**Objection to Development Application No. 0477/16 for Construction of Mooring Pens at 1 Kalinya Street, Newport**

## **Engineering Report**

### **Proposed Marina Development**

Development Application No 477/16

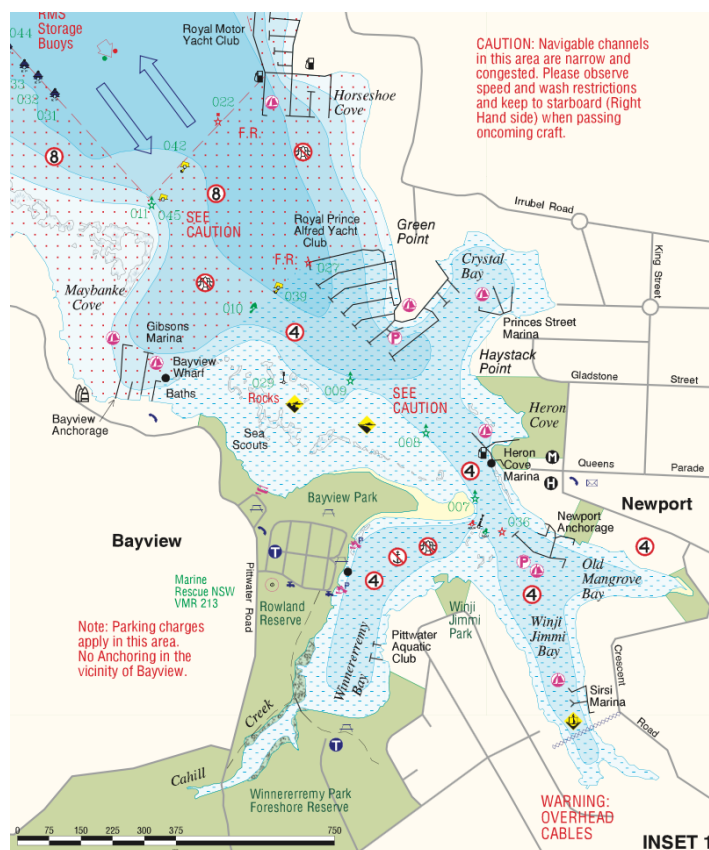
The Transport RMS letter dated 4 July is identified in the public documents and is acknowledged. The letter provides conditional assessment that there are no navigational concerns. However, the condition stipulated by the RMS officer is a condition over third parties and relates to the capacity and behavior of the vessel skippers and how they operate their craft.

The condition contained in the RMS letter: “*Vessels on the channel side of the mooring pen be berthed stern side too only.*” is simply unenforceable and an admission by the RMS that the channel is narrow and that the proposal will have an adverse impact on the existing circumstance,

The RMS Navigational chart for the region has a special navigation warning pertaining to the portion of Pittwater where the development is proposed. The chart warning states:

*“CAUTION: Navigable channels in this area are narrow and congested. Please observe speed and wash restrictions and keep to starboard (right) when passing oncoming craft”*

A survey of vessels moored in the waterways identified as Old Mangrove, Winji Jimmi and Winnererremy Bays found that there are a number of vessels that are over 30m and thus the minimum channel width prescribed by the Australian Standard is 45m, and the preferred width is 52.5m.

The channel created by the physical presence of a vessel berthed at the proposed development and the western channel boundary, as defined by the RMS starboard channel marker has been calculated at 40m<sup>1</sup>, and does not comply with the minimum width prescribed by the Australian Standard.

The proposal should be refused on the basis that it creates a public access channel that does not comply with the minimum channel width requirements of Australian Standard 3962.
